Subject: GROAN NOISE FROM FRONT WHEEL HUB	Bulletin No: 03-006/15
	Last Issued: 09/29/2015

BULLETIN NOTE

- This bulletin supersedes the previous bulletin 03-003/14, issued on 07/16/2014. The APPLICABLE MODEL(S)/VINS, PART(S) and WARRANTY INFORMATION have been revised.
- Changes are noted below in Red beside the change bar.

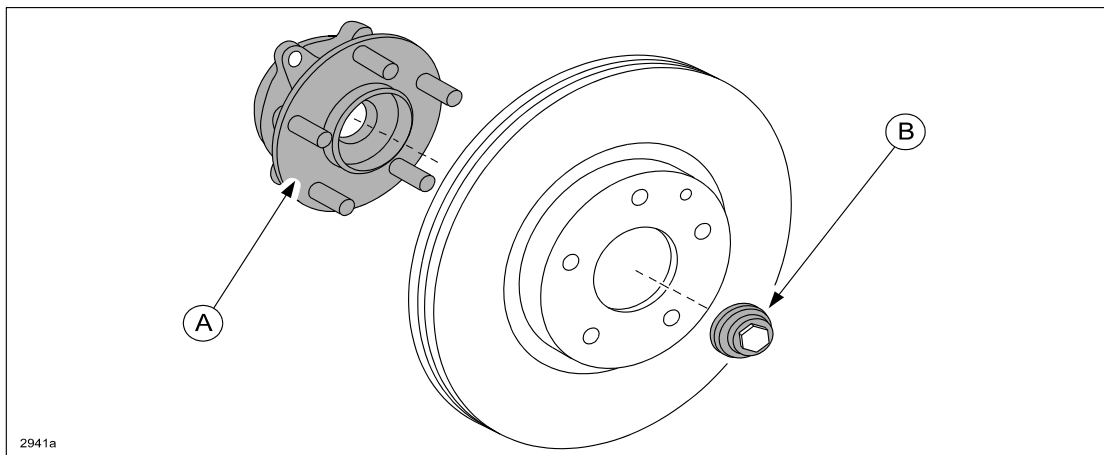
1. Verify customer concern.
2. Replace the affected front wheel hub (A) and locknut (B). Refer to MS3 online or Workshop Manual (section 03-12) removal/installation instructions for the front wheel hub and the locknut only.
 - CX-5 - WHEEL HUB COMPONENT REMOVAL/INSTALLATION [AWD]
 - Mazda6 - WHEEL HUB, STEERING KNUCKLE REMOVAL/INSTALLATION

Part Number	Description	Qty.	Notes
D651-33-042A	Locknut	1 or 2	Only replace the affected side. Replace both locknut and wheel hub as a set.
KD35-33-04XD	Wheel Hub	1 or 2
